<b>To:</b>	ATA Architects Inc. 211 Lakeshore Road East Oakville, Ontario L6J 1H7	<b>No.:</b>	<b>ADD-M03</b>
<b>Fax/Email:</b>	mark@ataarchitectsinc.com	<b>Date:</b>	November 4, 2024
<b>Attention:</b>	Mark Driedger	<b>Project:</b>	Fire Hall 7-1 835 Clark Ave. W., Vaughan, ON
<b>From:</b>	Cassandra Kani-Sanchez	<b>Project No.:</b>	<b>2021-0158</b>

This Addendum shall be attached to the drawings and specifications and shall form an integral part of the Contract Documents. The contents of this Addendum shall be brought to the attention of all concerned.

**1 MAIN FLOOR**  
 MD101 1:100

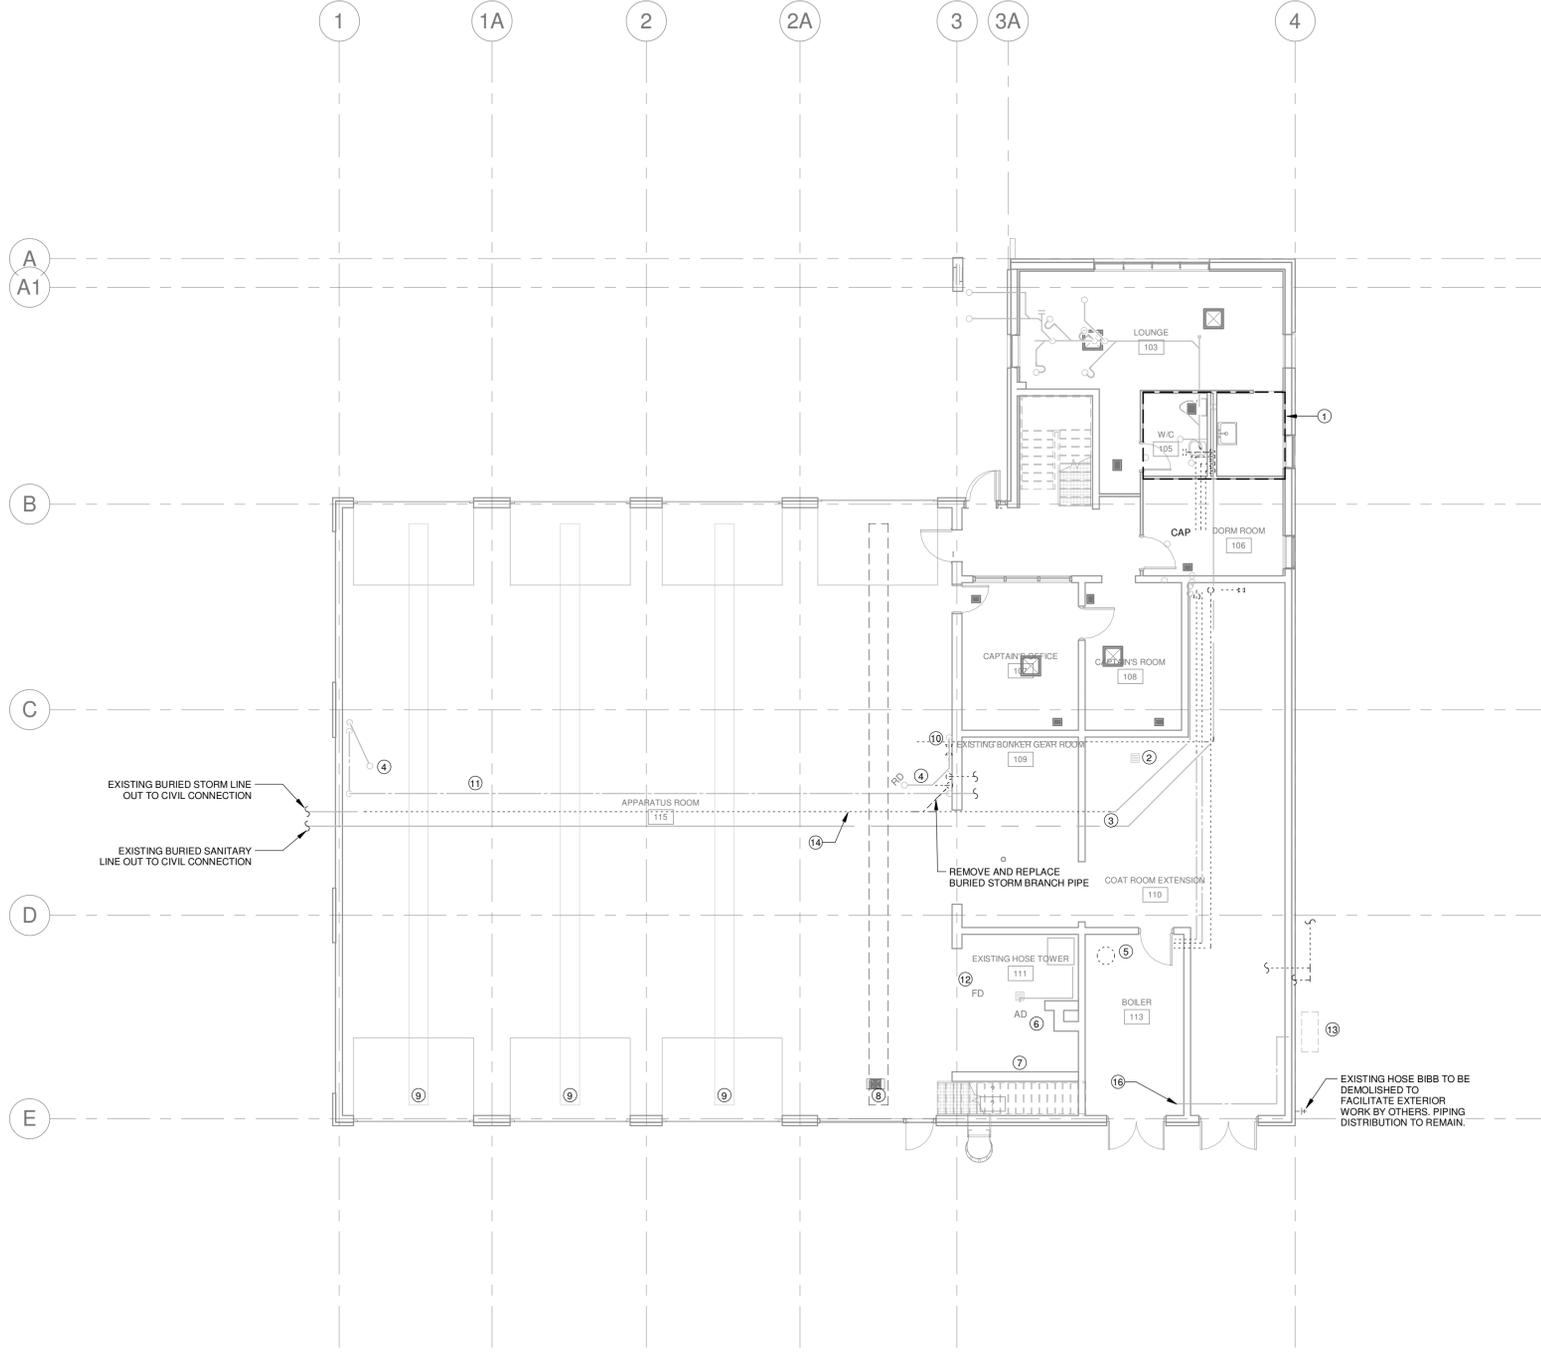
2.1. **Drawing MD101 – Ground Floor Plumbing & Drainage Demo (drawing re-issued)**

- 2.1.1. Drawing Note 4 revised, in its entirety, to read “Existing storm drain to remain. Remove and replace existing roof drains; connect to existing maintained storm drain piping below roof. Note that this Scope of Work is excluded from the Base Bid Price, to be paid by Cash Allowance under Section 01 21 00 Allowances.”
- 2.1.2. Drawing Note 13, deleted, in their entirety, the final three sentences of this Note and substitute with “Additional costs incurred from Gas Utility for upgrades wall be covered by Cash Allowance under Section 01 21 00.”
- 2.1.3. Drawing Note 14, revised, in its entirety, to read “remove and replace existing block storm main below slab. Prior to cutting Contractor to scan / X-ray to determine exact location and any potential other below slab services. Base Bid Price to include for this Scope of Work.”

- EXISTING STORM DRAIN TO REMAIN. REMOVE AND REPLACE EXISTING ROOF DRAINS; CONNECT TO EXISTING MAINTAINED STORM DRAIN PIPING BELOW ROOF. NOTE THAT THIS SCOPE OF WORK IS EXCLUDED FROM THE BASE BID PRICE, TO BE PAID BY CASH ALLOWANCE UNDER SECTION 01 21 00 ALLOWANCES. (TYPICAL)

**1 SECOND FLOOR**  
 MD102 1:100

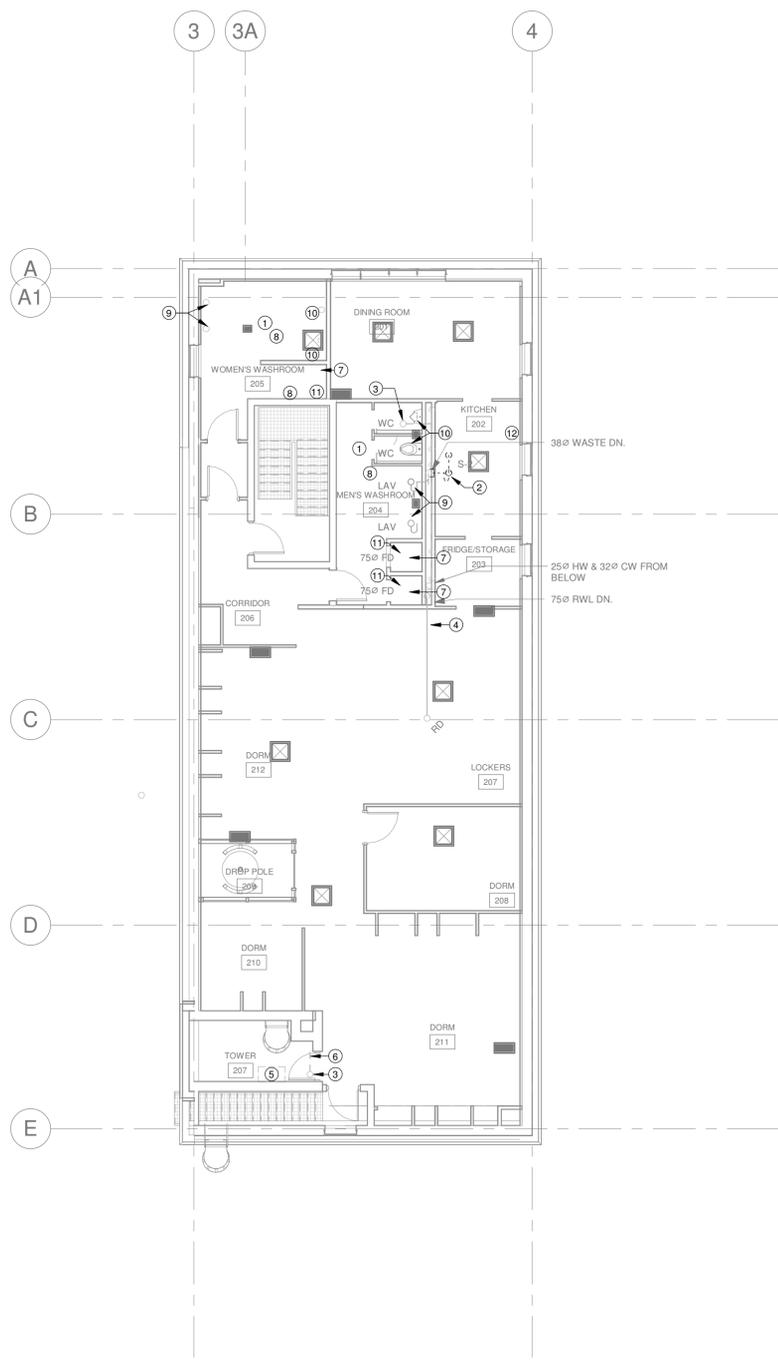
2.2. Drawing MD102 – Ground Floor Plumbing & Drainage Demo (drawing re-issued)

2.2.1. Drawing Note 4, revised, in its entirety, to read “Existing storm drain to remain. Remove and replace existing roof drains; connect to existing maintained storm drain piping below roof. Note that this Scope of Work is excluded from the Base Bid Price, to be paid by Cash Allowance under Section 01 21 00 Allowances.”

- EXISTING 75Ø SANITARY VENT LINE UP THROUGH ROOF TO REMAIN. (TYPICAL EOP R 2)
  - EXISTING STORM DRAIN TO REMAIN. REMOVE AND REPLACE EXISTING ROOF DRAINS. CONNECT TO EXISTING MAINTAINED STORM DRAIN PIPING BELOW ROOF. NOTE THAT THIS SCOPE OF WORK IS EXCLUDED FROM THE BASE BID PRICE, TO BE PAID BY CASH ALLOWANCE UNDER SECTION 01 21 00 ALLOWANCES. (TYPICAL)

**MD103**

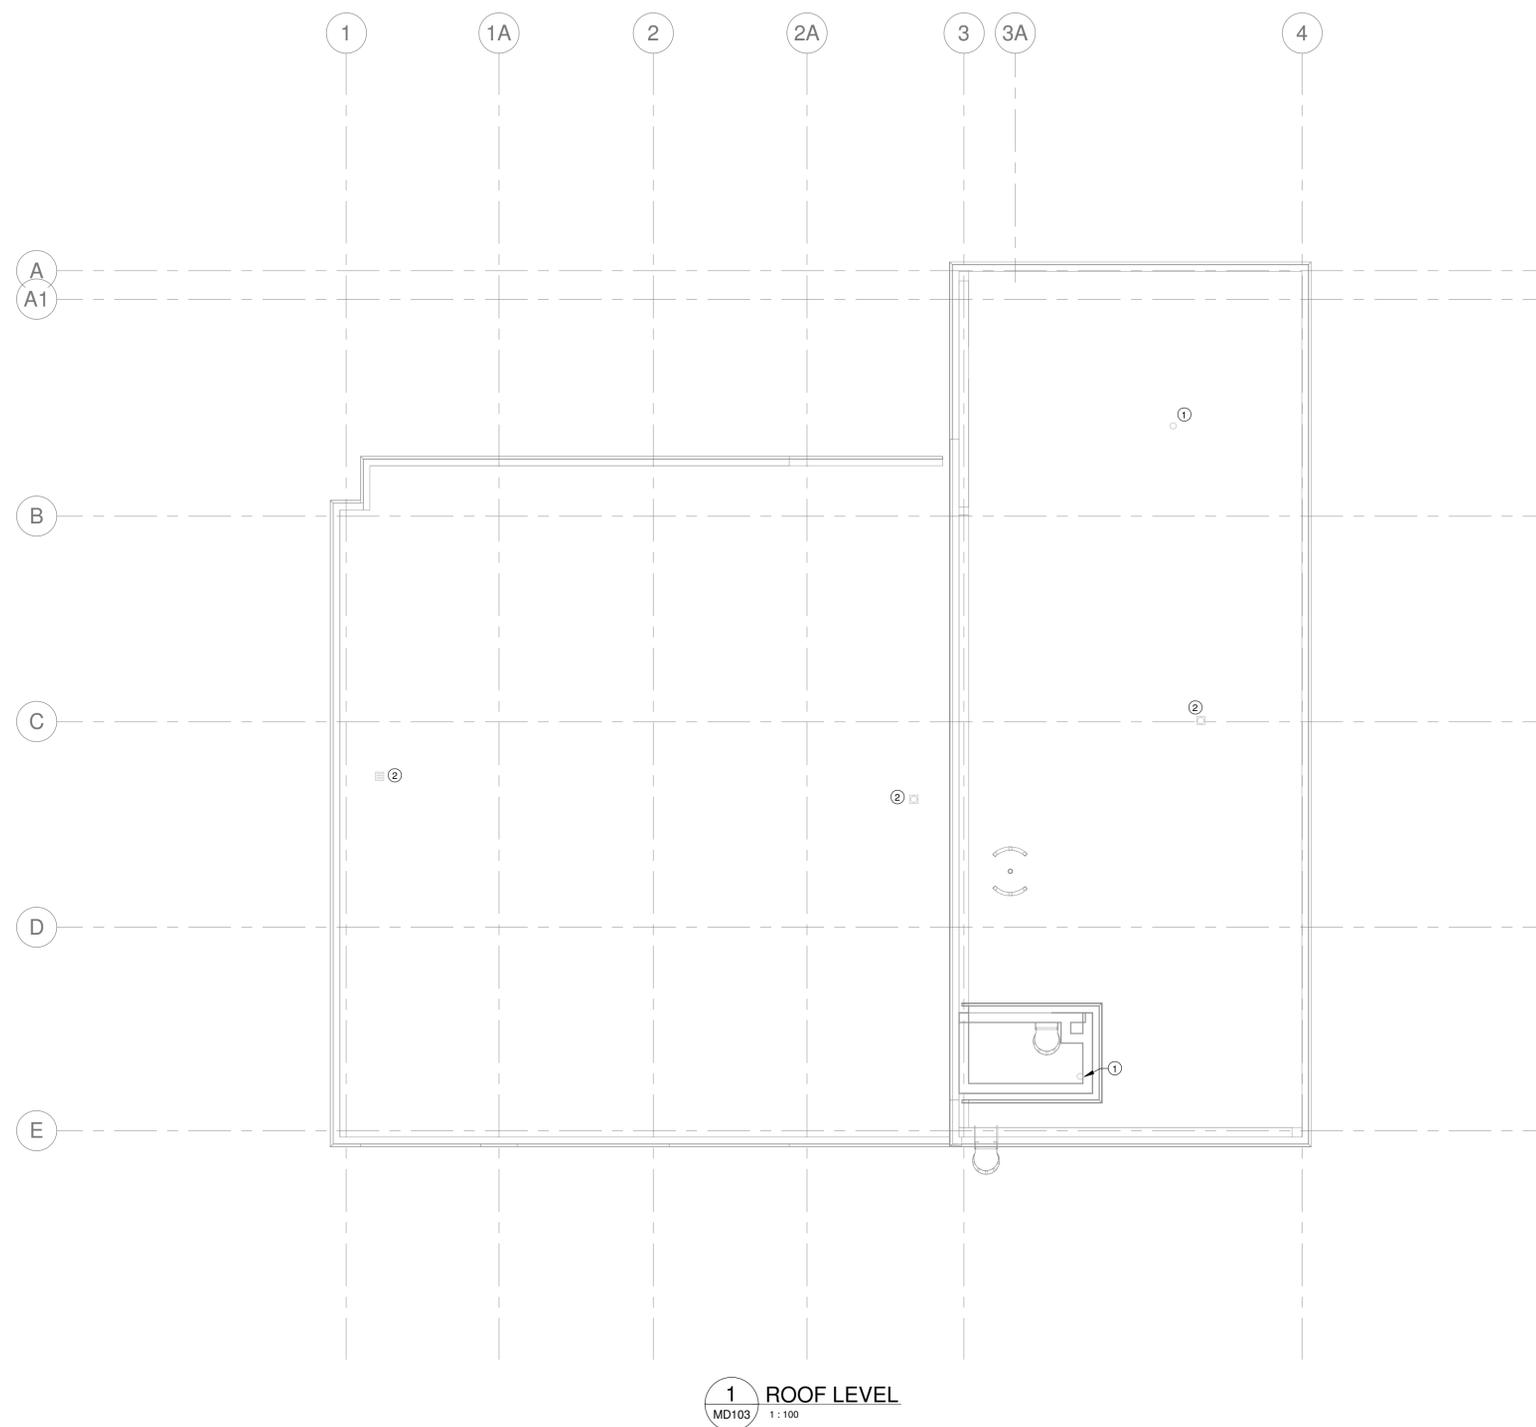
2.3. Drawing MD103 – Ground Floor Plumbing & Drainage Demo (drawing re-issued)

2.3.1. Drawing Note 2, revised, in its entirety, to read “Existing storm drain to remain. Remove and replace existing roof drains; connect to existing maintained storm drain piping below roof. Note that this Scope of Work is excluded from the Base Bid Price, to be paid by Cash Allowance under Section 01 21 00 Allowances.”

- EXISTING 50 SANITARY VENT LINE UP THROUGH ROOF TO REMAIN. (TYPICAL FOR 2)
- EXISTING MAINTAINED STORM DRAIN TO REMAIN. REMOVE AND REPLACE EXISTING ROOF DRAINS; CONNECT TO EXISTING MAINTAINED STORM DRAIN PIPING BELOW ROOF. NOTE THAT THIS SCOPE OF WORK IS EXCLUDED FROM THE BASE BID PRICE, TO BE PAID BY CASH ALLOWANCE UNDER SECTION 01 21 00 ALLOWANCES. (TYPICAL)

**M100**

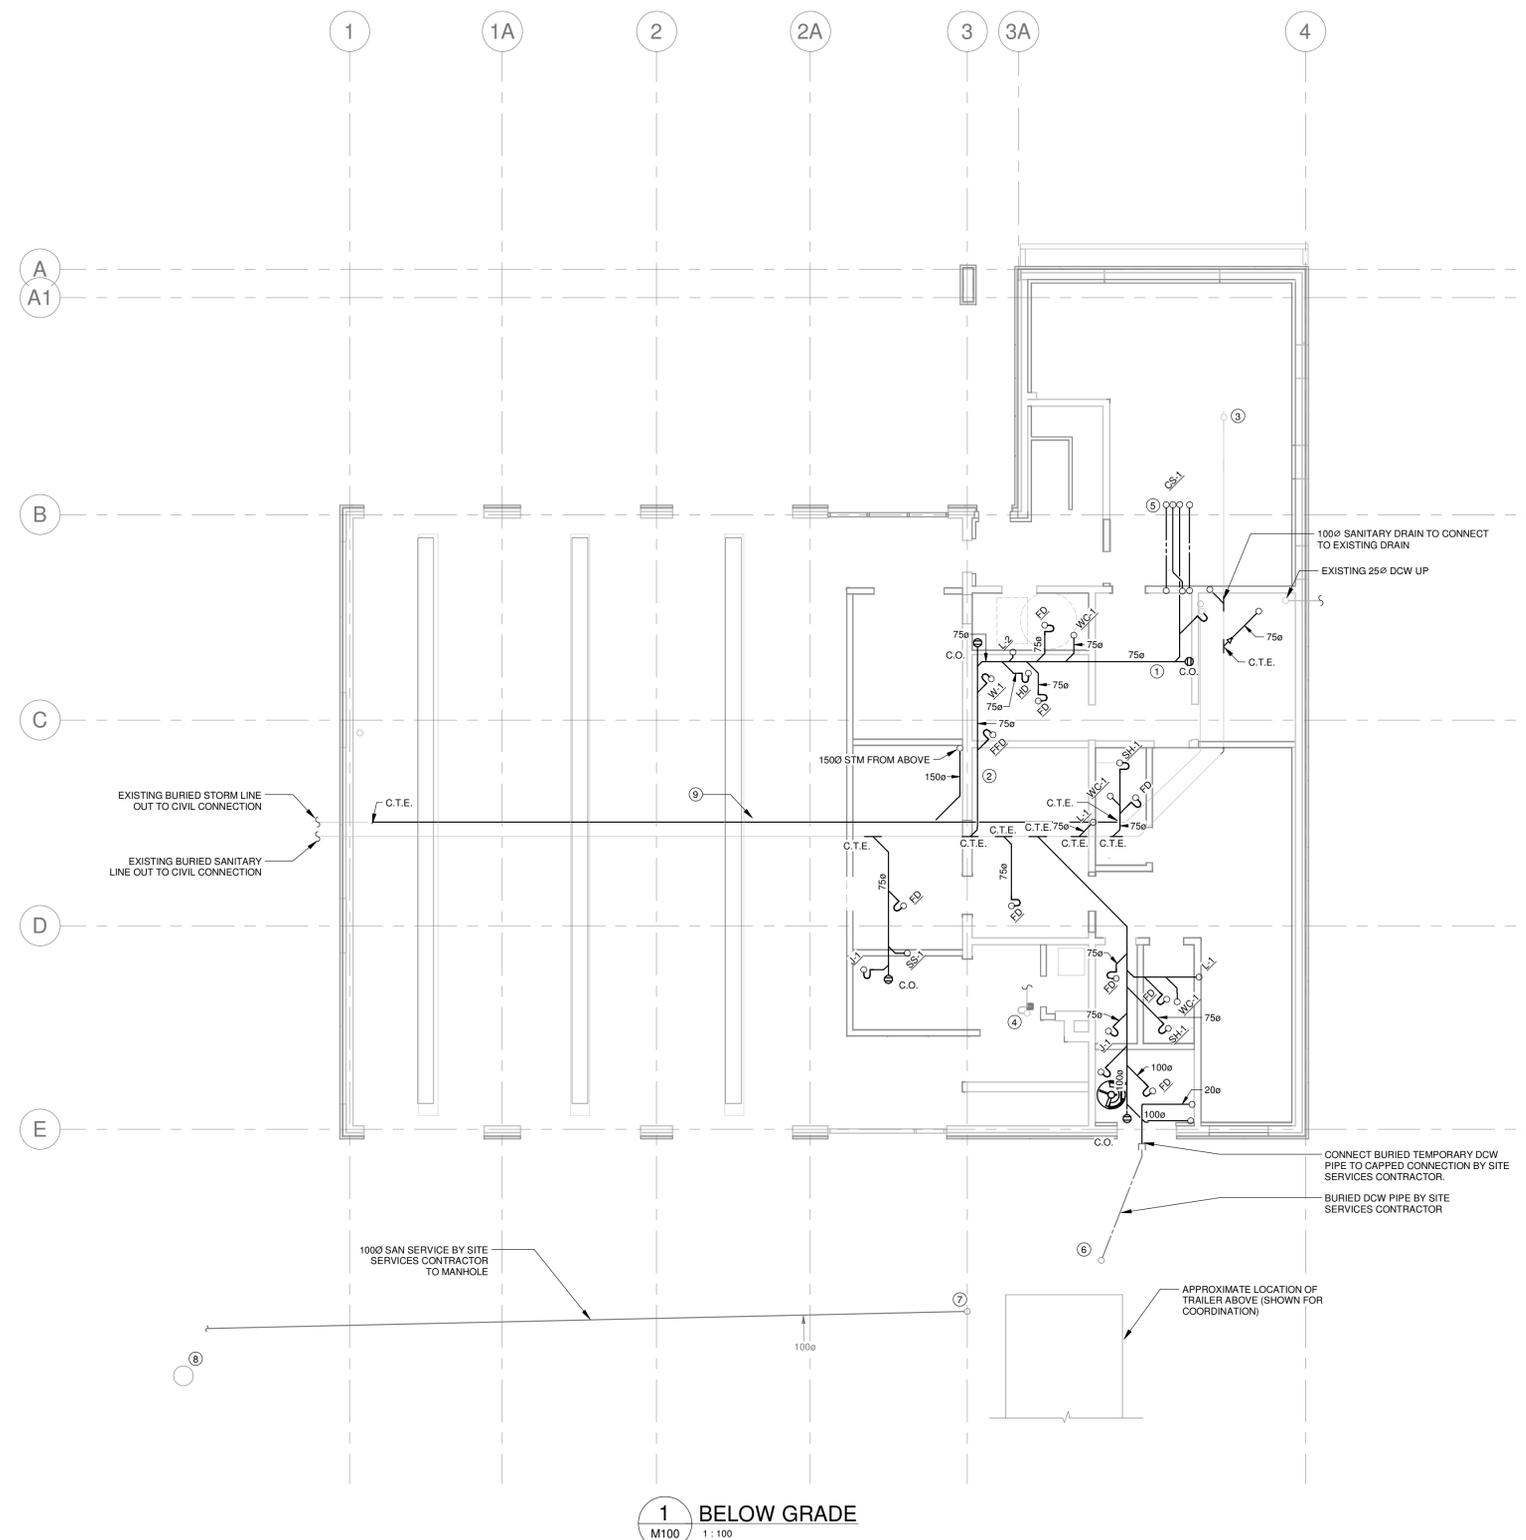
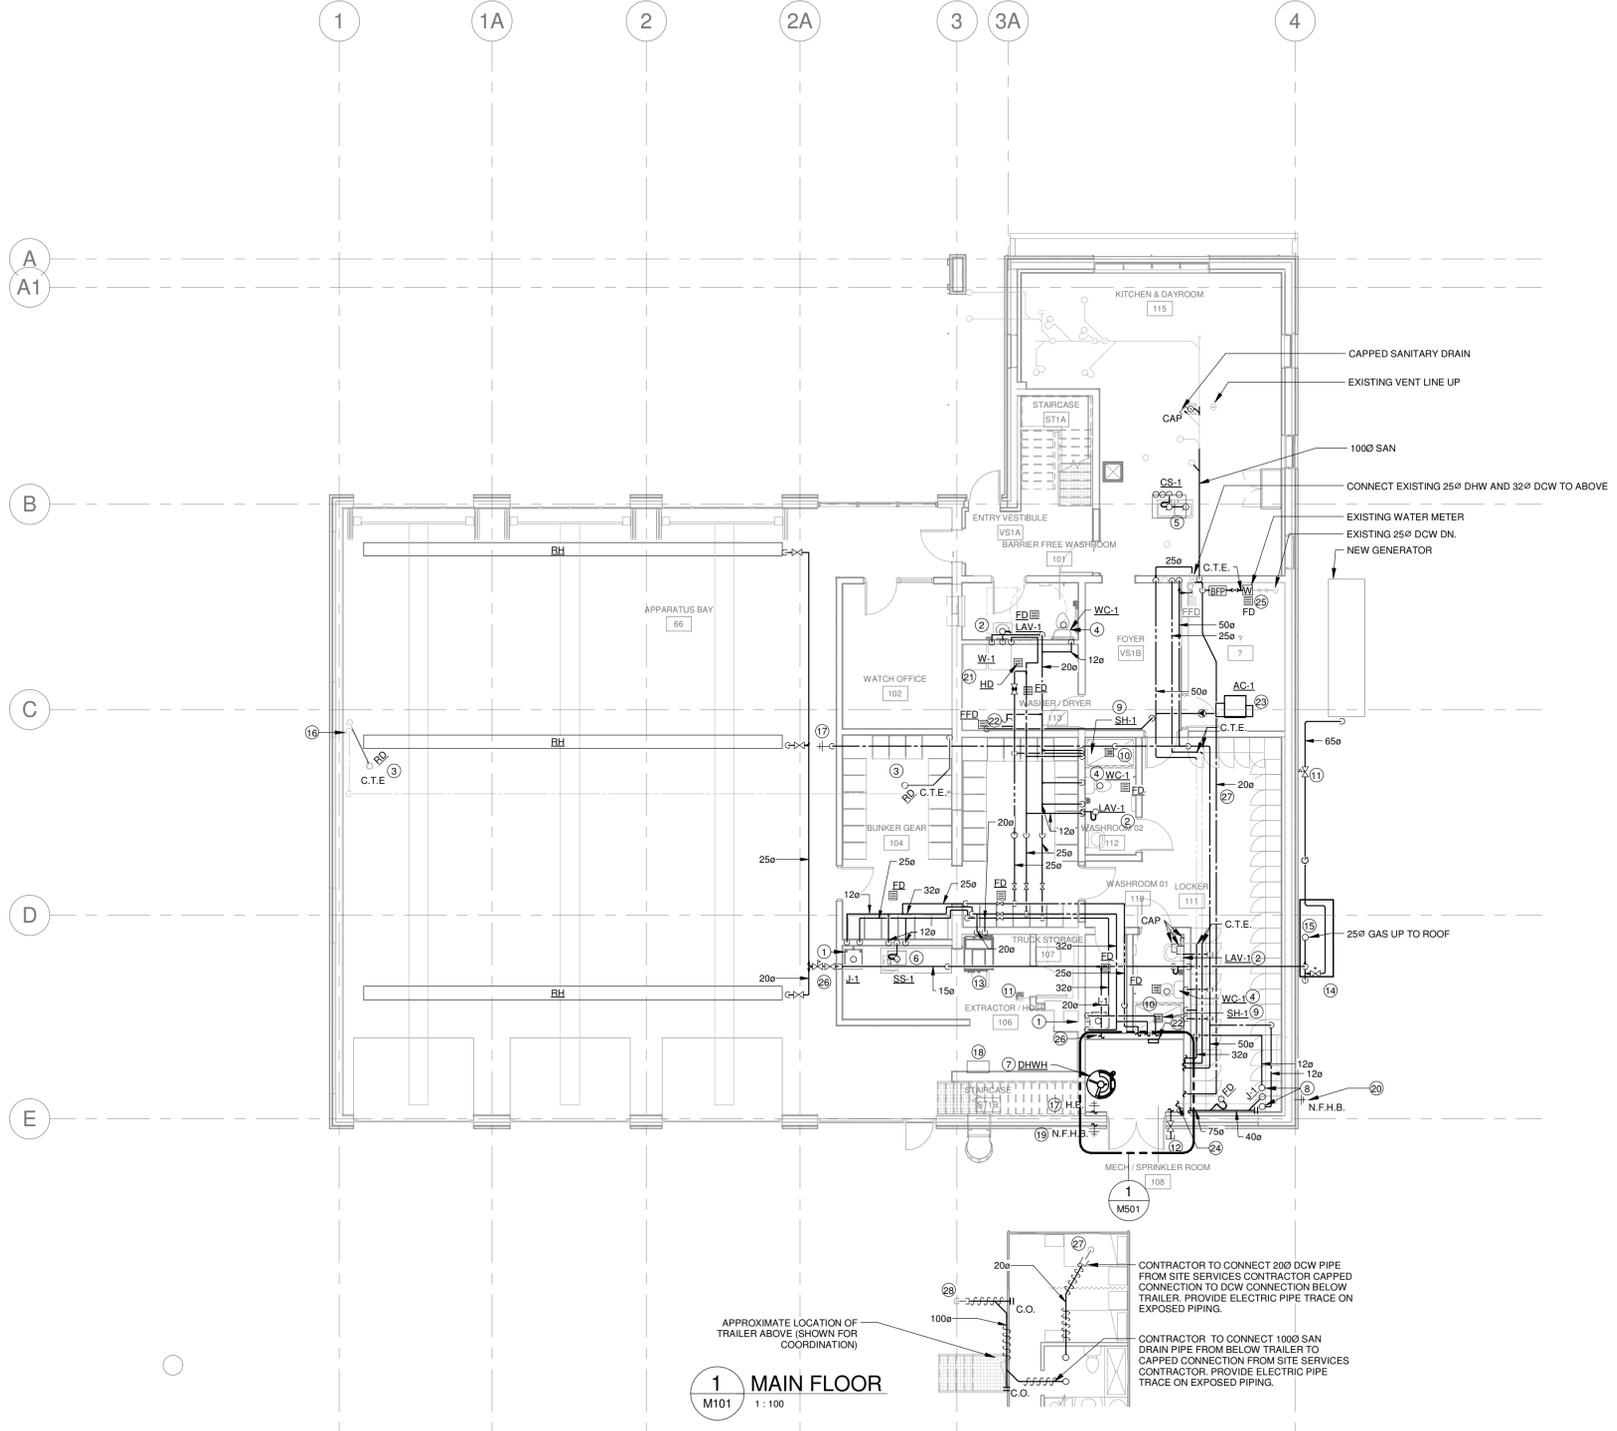
2.4. Drawing M100 – Ground Floor Plumbing & Drainage (drawing re-issued)

2.4.1. Drawing Note 9, revised, in its entirety, to read “Replace existing blocked storm main below slab. Base Bid Price to include for this Scope of Work.”

- APPROXIMATE LOCATION OF EXISTING MANHOLE SHOWN FOR REFERENCE.
  - REPLACE EXISTING BLOCKED STORM MAIN BELOW SLAB. BASE BID PRICE TO INCLUDE FOR THIS SCOPE OF WORK.
